(DRAFT)

**MACQUARIE POINT MULTIPURPOSE STADIUM PROJECT OF STATE SIGNIFICANCE
(PoSS) - Draft Integrated Assessment Report (IAR)**

Figure 2. Stepped boundary issues between MPDC & TasPorts

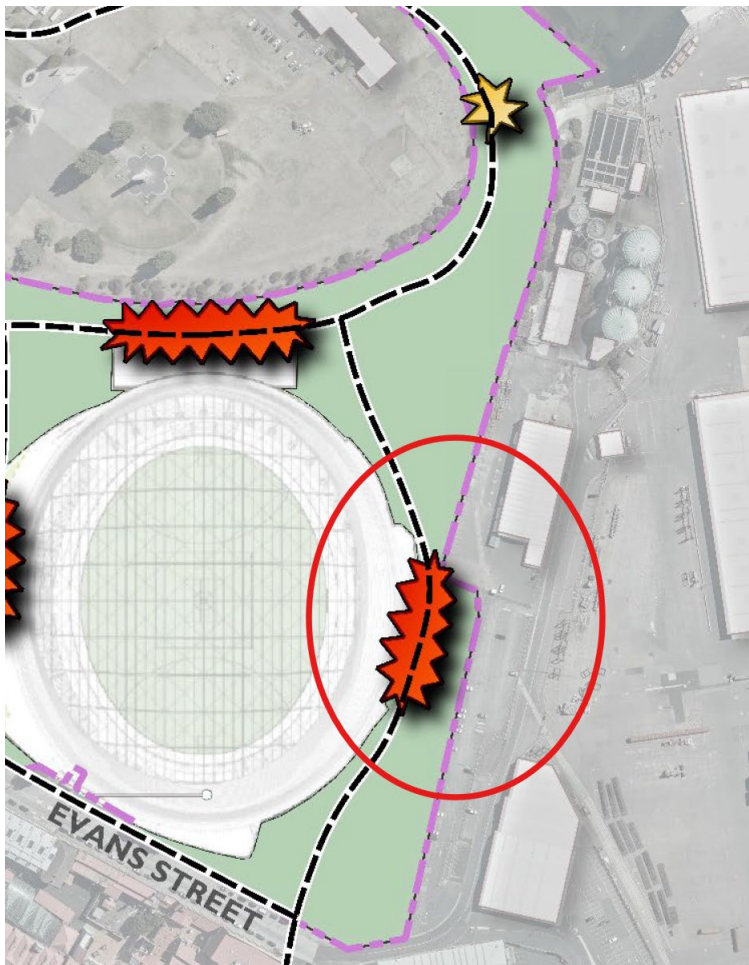
(j) The City agrees with the Panel that in order to improve functionality and safety of the proposed stadium design, additional dedicated space around the stadium building should be sort. The City implores the proponent and TasPorts to consider adjusting the eastern stepped boundary (as shown on Figure 2 below) as a matter of priority to allow for the full realisation of the Complementary Integrated Mixed Use Zone and Antarctic Facilities Zone as originally envisaged which will also go some way to alleviate some of the many pinch points identified around the precinct.
